| Project | IEEE 802.16 Broadband Wireless Access Working Group < http://ieee802.org/16 > | |
| Title | Fast cell search for OFDMA | |
| Re: | IEEE 802.16e D3 Draft | |

Figure AAA: A new preamble used as a common SYNC channel

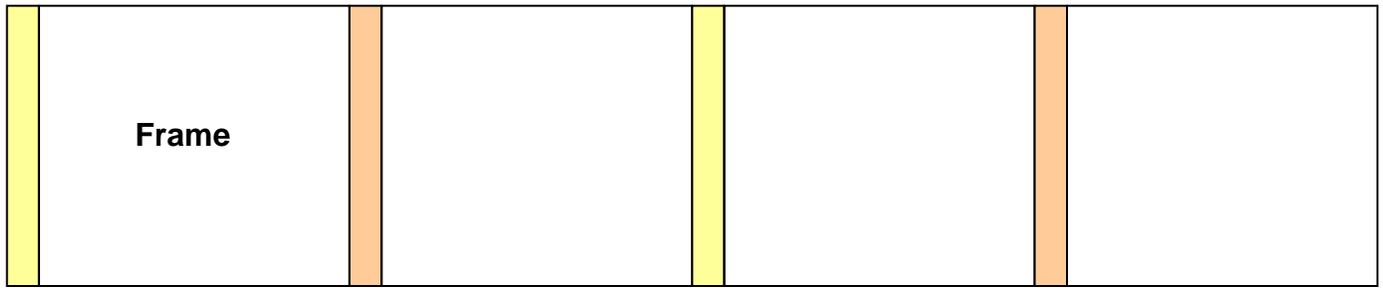
A new preamble is inserted into the frame structure alternatively with the existing preamble as shown in the Figure AAA. This new preamble is used as a common SYNC channel.
